**RE: Petition for Reconsideration of Final Rule NHTSA Docket 2023-0021**

### **Legal and Engineering Support of Petition for Reconsideration of the Final Rule Adopting Requirements for Automatic Emergency Braking**

**NHTSA Docket 2023-0021**

**Figure 1 - Surface friction versus surface temperature example**

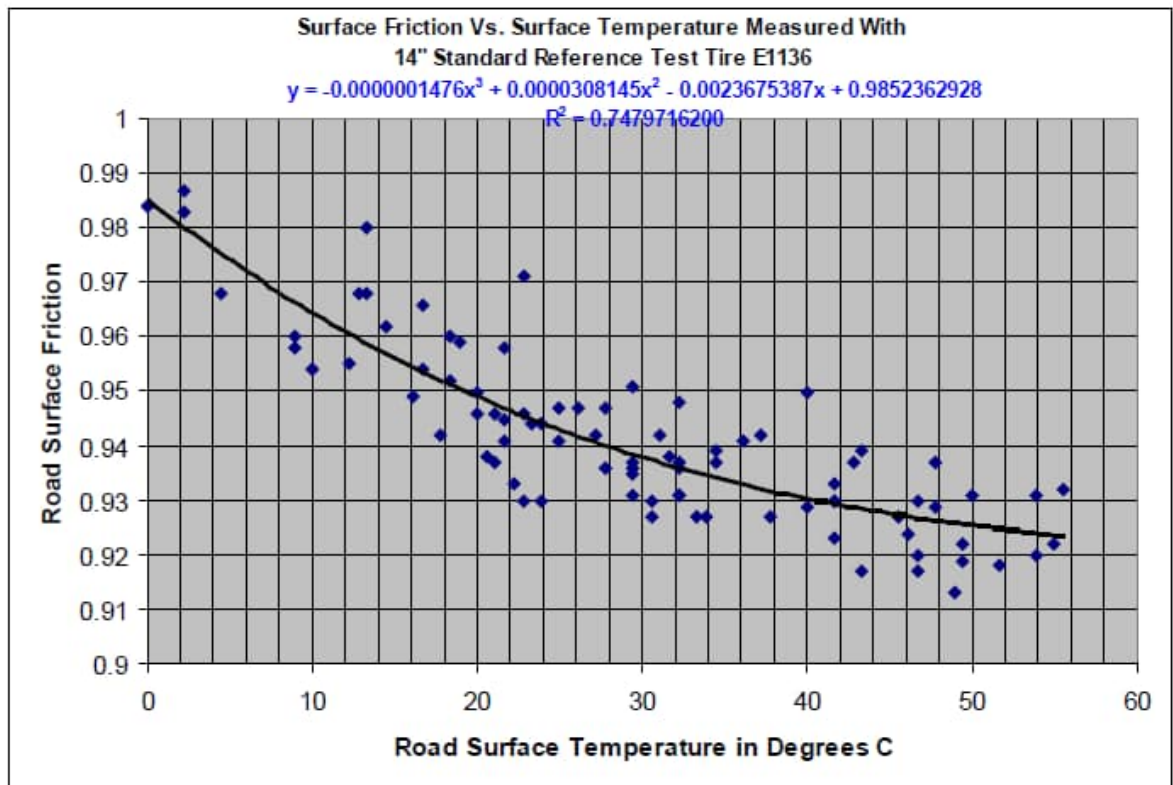
The figure below, from SAE J2909, “Light Vehicle Dry & Wet Stopping Distance Test Procedure” demonstrates the range of surface frictional coefficients that can occur across the allowable ambient temperature range specified in the Final Rule (0° C - 40° C).

In addition to temperature, other ambient conditions contributing to test performance variation include things like cloud cover (or intermittent cloud cover, especially), dust, debris, pollen effects, recent rainfall, and other noise factors. These variations in ambient conditions can easily translate into about 8-10 feet (2.5-3m) or more variation in absolute stopping distance on any given test surface.

Figure 30: Distribution of TTC for Nissan Altima for S1 Tests Conducted at 16 km/h

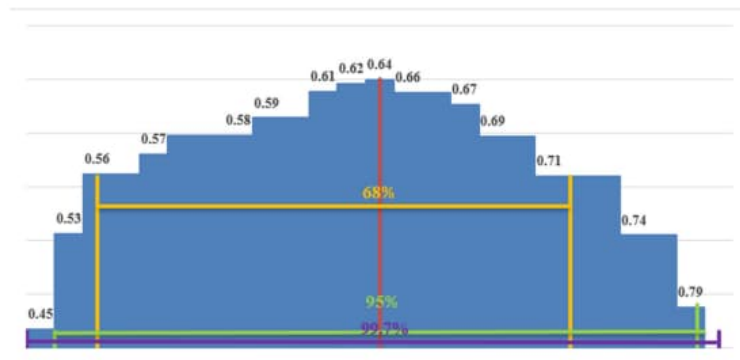
was assessed at the Final Rule speed of 62.1mph (100 km/h). Even at these lower speeds, the NHTSA data show a variation of at least 0.15 seconds in TTC, in addition to any other stacking variations due to test set up and other variables. Below are three figures from NHTSA's FRIA showing this variability:

Figure 32: Distribution of TTC for Subaru Outback for S1 Tests Conducted at 40 km/h

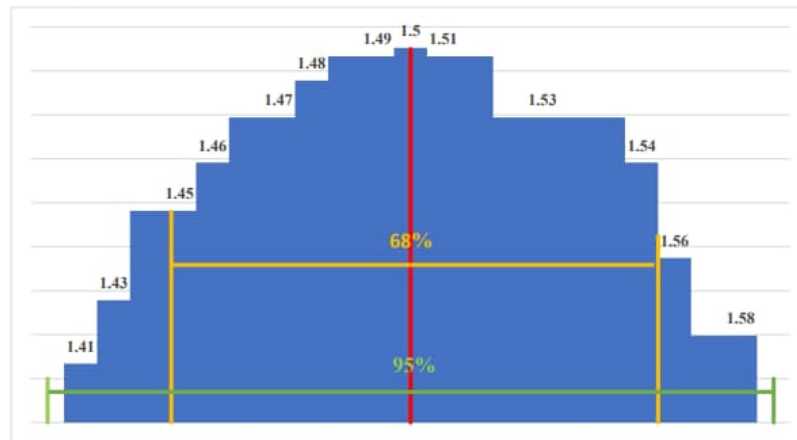
When these data are considered in the context of the requirements of the Final Rule, the practicability problems become clear. The following example illustrates the problem:

## Example for Obstructed Pedestrian Crossing Scenario

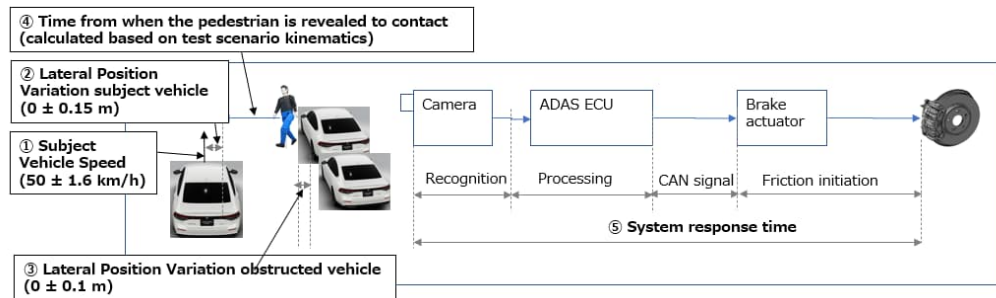
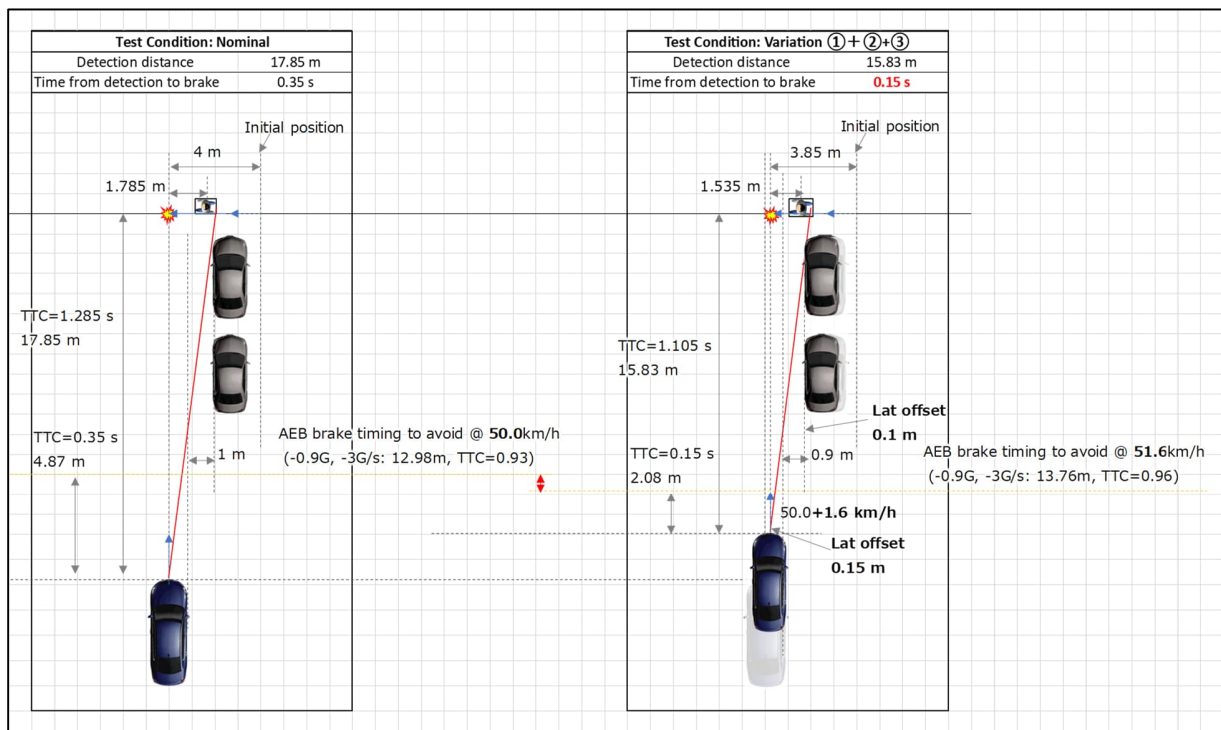
For the obstructed pedestrian crossing road scenario required in S8.2, assuming the following:

- Variation in subject vehicle test speed of  $31 \text{ mph} \pm 1 \text{ mph}$  ( $50 \text{ km/h} \pm 1.6 \text{ km/h}$ ) as specified by S7 of the Final Rule (tolerance 1 in the chart below);
- Variation in subject vehicle lateral position (overlap to pedestrian) of  $0 \pm 0.15 \text{ m}$  as specified by S8.1.2 (tolerance 2 below);
- Variation in the lateral position of the obstructing vehicles (with respect to pedestrian position) of  $0 \pm 0.1 \text{ m}$  as specified by S8.3.3 (tolerance 3 below); and
- AEB can achieve peak braking deceleration of  $0.9 \text{ G}$  with an initial braking input rate of  $3 \text{ G}$  per second. This is considered ideal best case but for the purposes of this example, variation is not included.

Under nominal test scenario conditions, the pedestrian is revealed from behind the obstructing vehicle at 1.285 seconds TTC, which demands that the AEB system respond (recognize, process, signal, and initiate braking friction) within 0.35 seconds to avoid contact (i.e. 0.93 sec TTC at brake activation). However, considering the aforementioned variation in testing choreography for speed and position, the pedestrian is revealed in as little as 1.015 seconds TTC. Therefore, the Final Rule actually demands 0.15 seconds response time, which is well beyond the capability of any known AEB system.

These theoretical variations in calculated AEB system response times directly support the TTC variation that NHTSA highlights in the FRIA. Together, these demonstrate that the Final Rule TTC requirements (i.e. AEB system response times) are not practicable for the current fleet.
